# SERVICE BULLETIN

Subject: TS45 Pressure Sensor Pinout  
Changing Bulletin

Bulletin No: TS45-FC-2518

Vehicle Model: TS45

PART NUMBER	PART DESCRIPTION	QTY	SYMBOL
9402-105Y	T-FEMALE 0,5-1,0 mm <sup>2</sup>	3

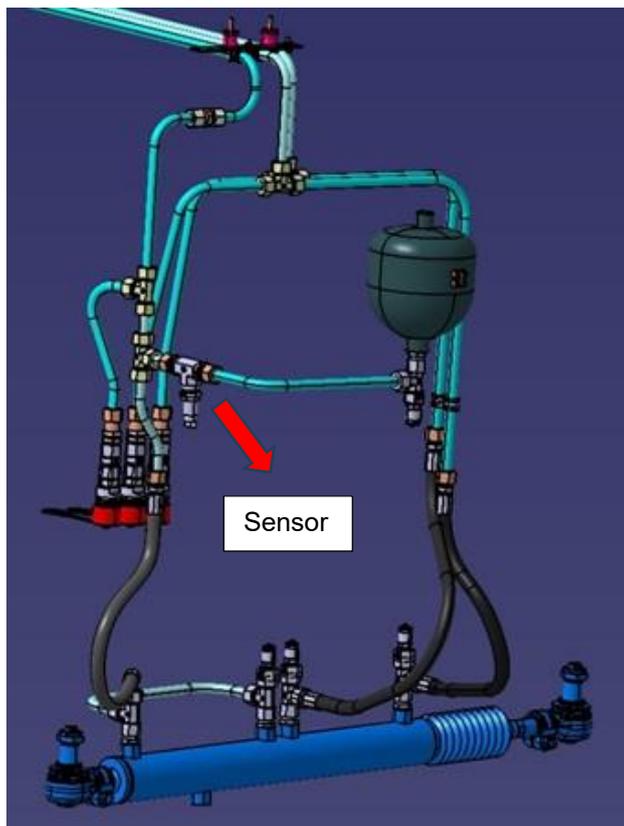
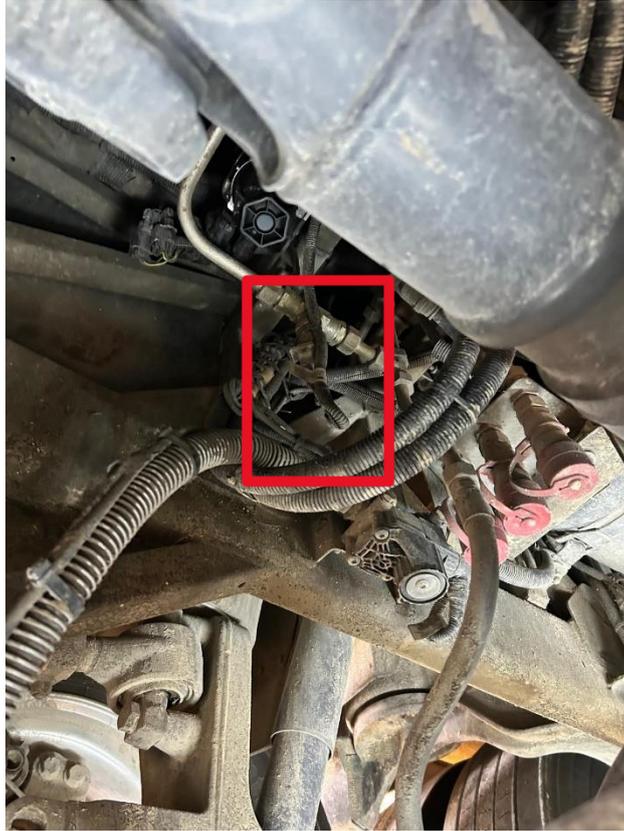
This part has been added in case the terminal is damaged when removing the cables from it.

**Note:** If the terminals are damaged when disconnecting the cable from the socket, cut the terminals from the cable. Insert terminal numbered 9402-105Y into the cable.

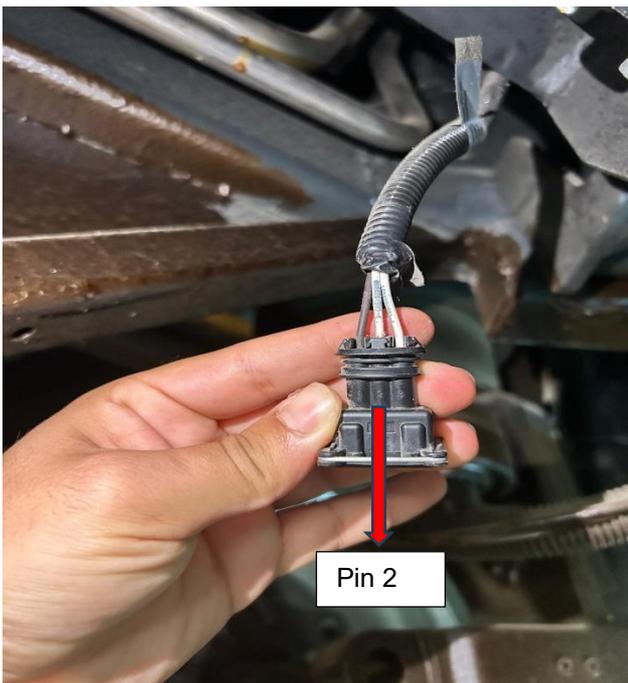
**2)** Carefully disconnect cable numbered 08N001(5V)-85-16 from pin 2 of the socket.

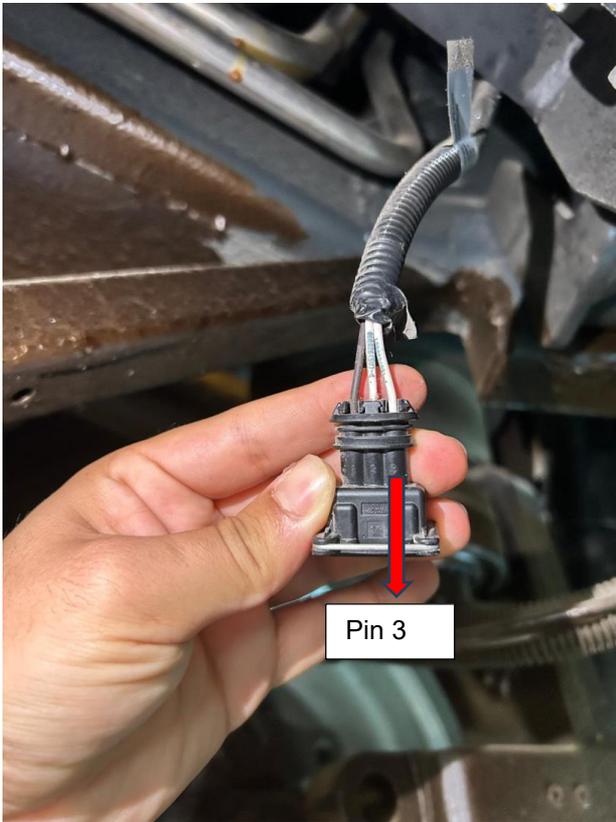
- 3) Carefully disconnect cable numbered 10B022(82)-1 from pin 3 of the socket.

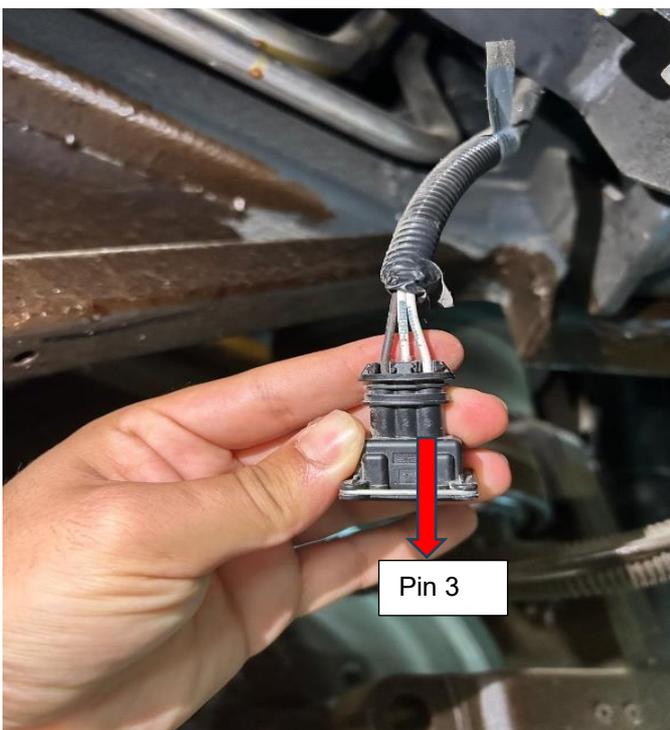
- 4) Connect cable numbered 08N001(5V)-85-16 to the third pin of the socket.

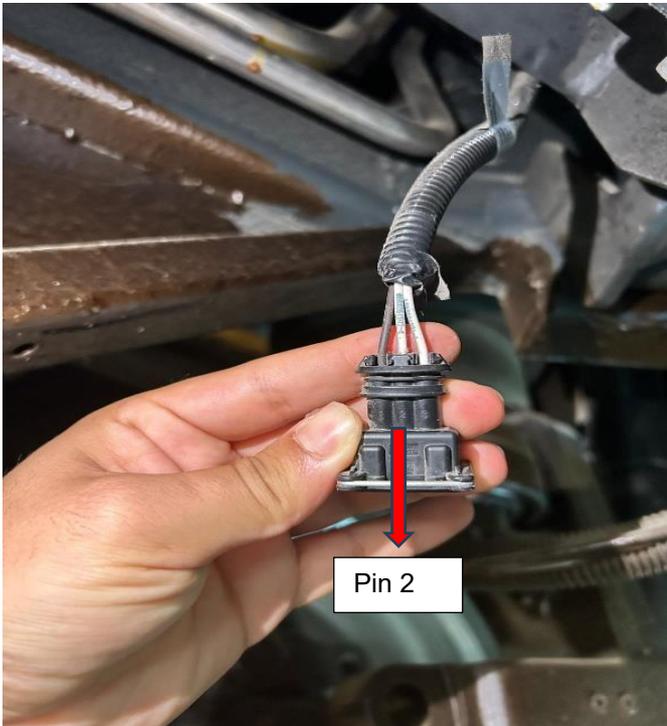
- 5) Connect cable numbered 10B022(82)-1 to the second pin of the socket.

- 6) Plug the socket back into position.
